**ADVICE IN RELATION TO THE POTENTIAL
IMPACTS OF COAL SEAM GAS EXTRACTION
IN THE SURAT AND BOWEN BASINS,
QUEENSLAND**

Phase One Final Report

**AUSTRALIAN GOVERNMENT
DEPARTMENT OF THE ENVIRONMENT,
WATER, HERITAGE AND THE ARTS**

Geoscience Australia and Dr M.A. Habermehl

Figure 2.1-2. Location of natural groundwater discharge sites (springs) with respect to coal seam gas tenements considered in the current assessment.

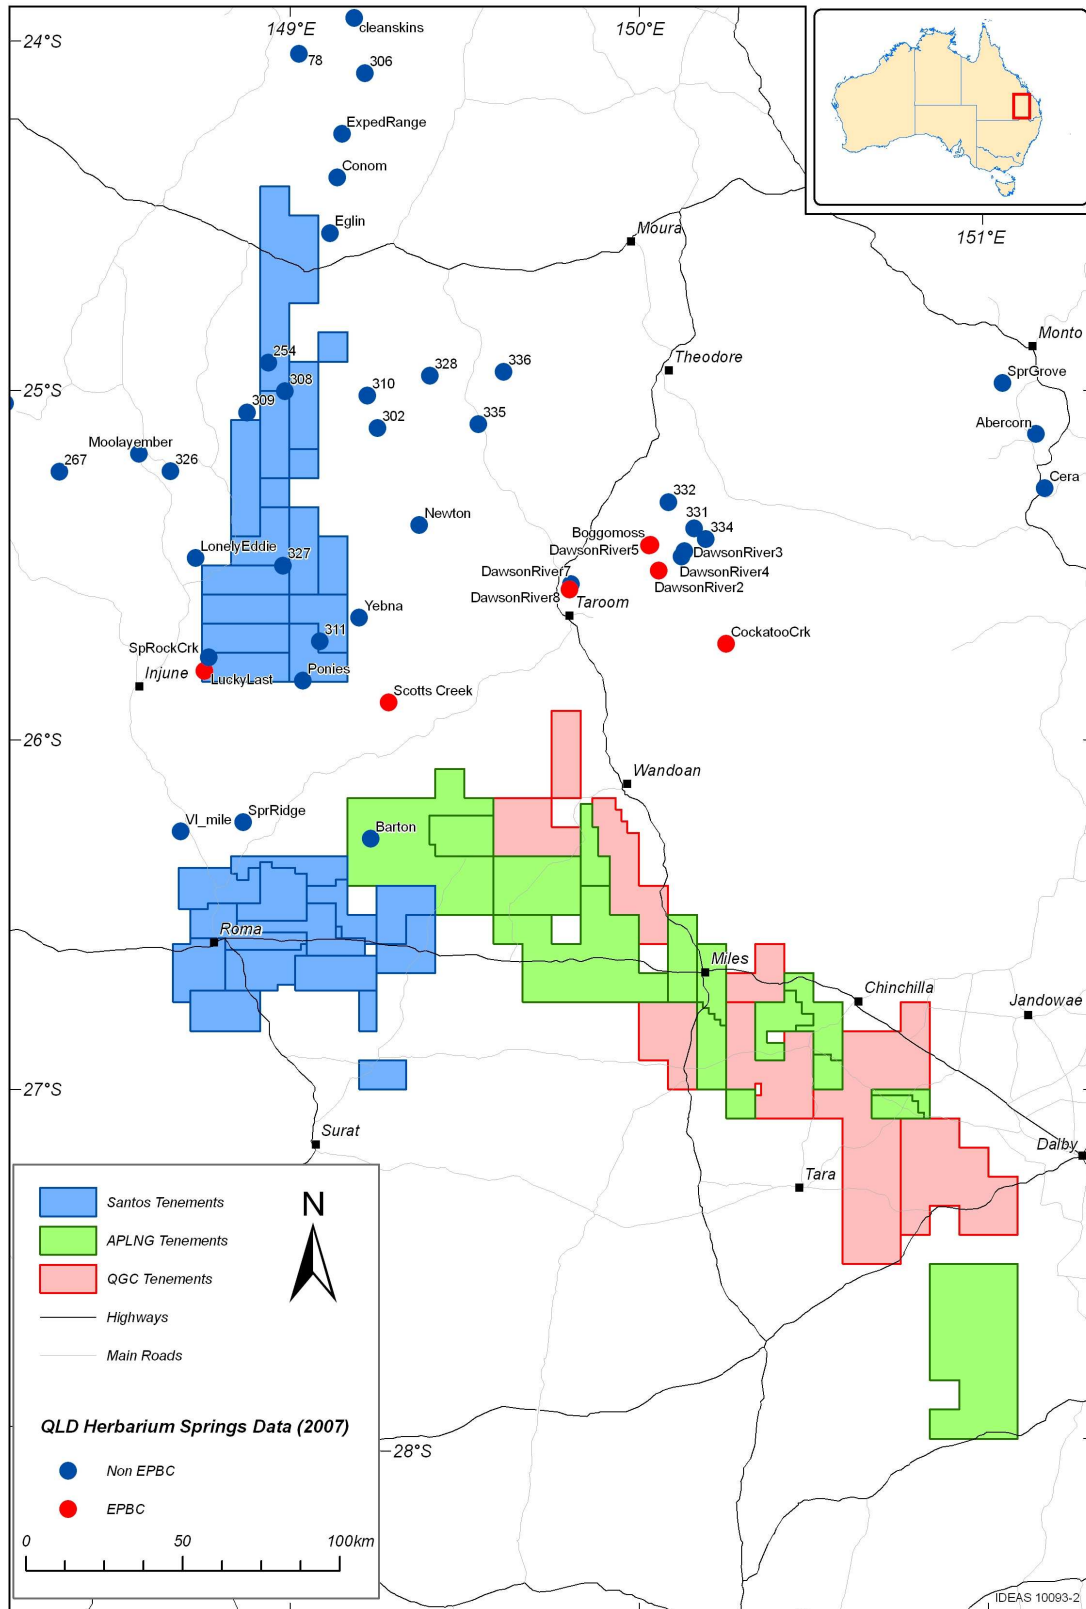
Only one registered “recharge” spring was identified within APLNG leases, in the western corner of the Pine Hills development area (Fig. 2.1-2). The spring is included on the Qld GAB WRP Springs Register and the Qld Herbarium database, but does not appear in the DEWHA mapping of Threatened Ecological Community - The Community of Native Species Dependent on Natural Discharge of Groundwater from the Great Artesian Basins. The spring is listed as ‘RJF Site No NV333’ and classified as active but not visited. APLNG hydrogeologists visited the site in July 2010 and reported no surface hydrological expression or vegetation indicative of a spring or GDE. The feature was reported as a possible seepage relating to an incised erosional feature at base of deep soil profile after significant rainfall (APLNG response to Geoscience Australia questions – 23 August 2010, p. 29).

APLNG identify numerous high value “recharge” and “discharge” spring complexes associated with the Hutton Sandstone and Precipice Sandstone units. These are located proximal to the Taroom and Injune townships, at least 50 km north and north-west of the northernmost APLNG development areas (DNR 2005). The “discharge” spring complexes located near Taroom are supplied by artesian flow from the Precipice Sandstone, rising to the surface through joints and fractures in that unit. These complexes are known locally as 'boggomosses', and provide a wetland habitat in an area that experiences prolonged below average rainfall conditions (DEWHA 2001) (APLNG Vol. 2, Ch. 10, p. 17).

Figure 2.2-2. Location of natural groundwater discharge sites (springs) with respect to coal seam gas tenements considered in the current assessment.

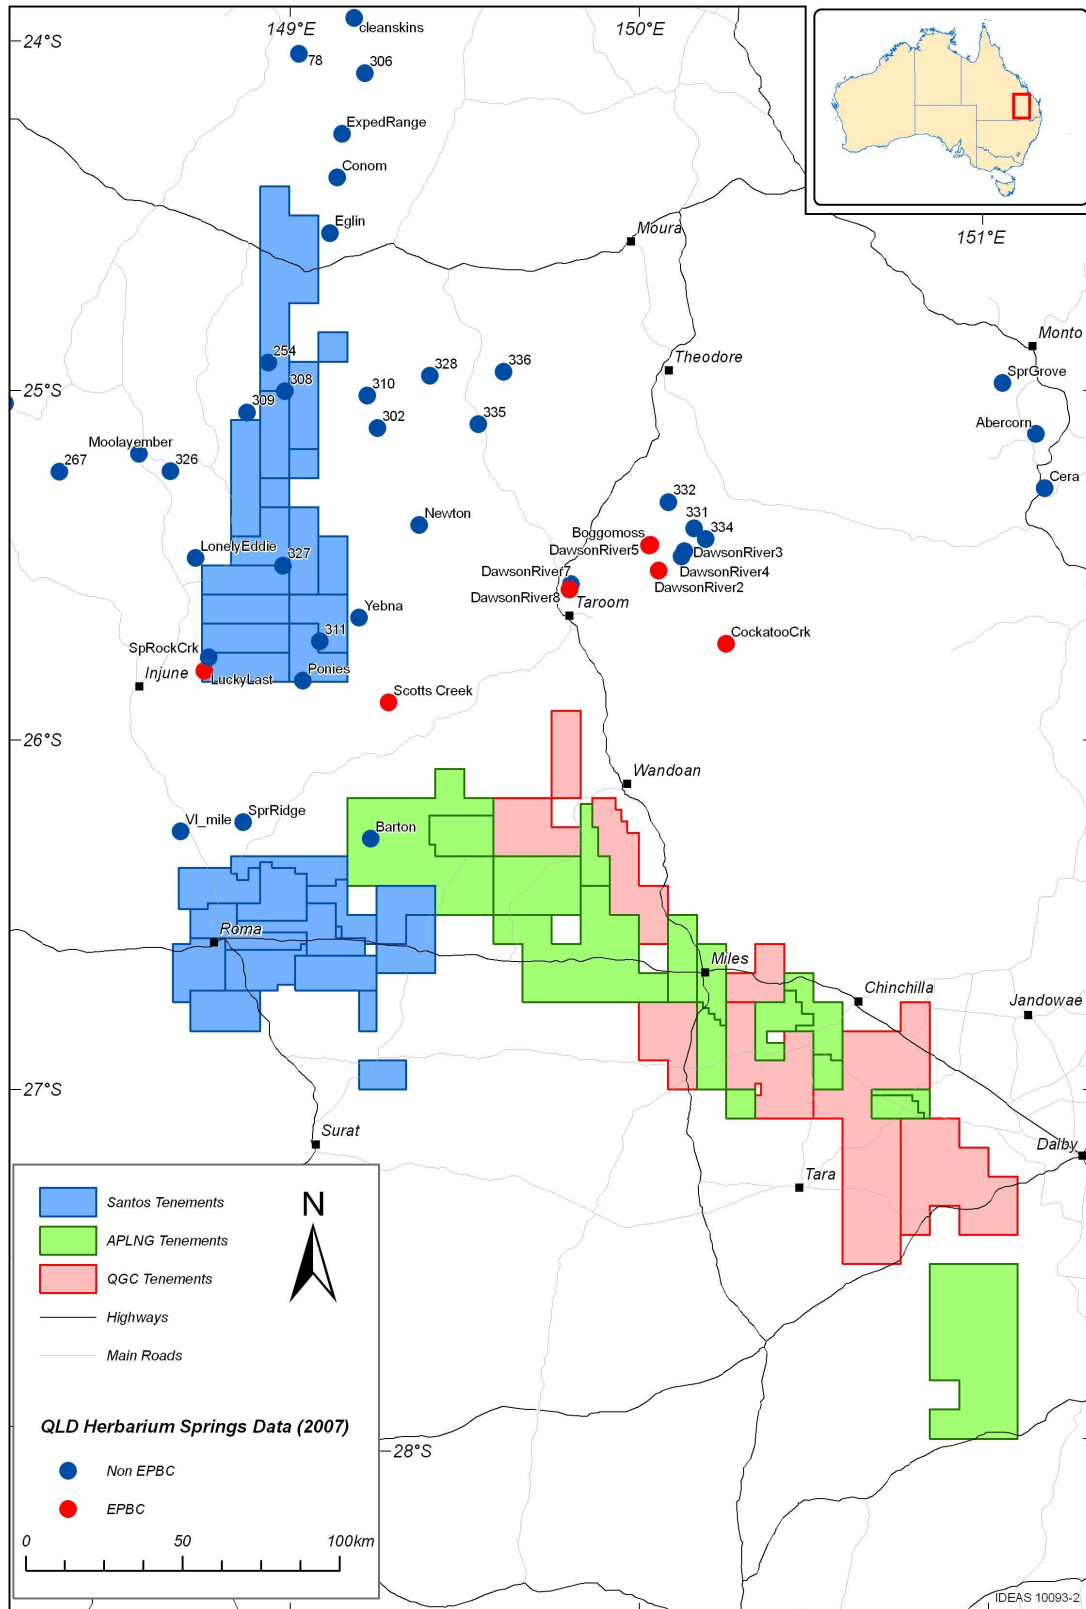
GA and Dr M.A. Habermehl also identify no EPBC listed communities within the QGC tenements or within the QGC modelled zone of depressurisation. Some springs (type unspecified) are noted by QGC within 30 to 50 km of the CSG project area. At 30 to 50 km from the CSG fields QGC predict that drawdown in the Springbok Sandstone aquifer (Injune Creek Group), Hutton Sandstone and Precipice Sandstone aquifers will be negligible (QGC App. 3.4, Rep. 7, p. 72).
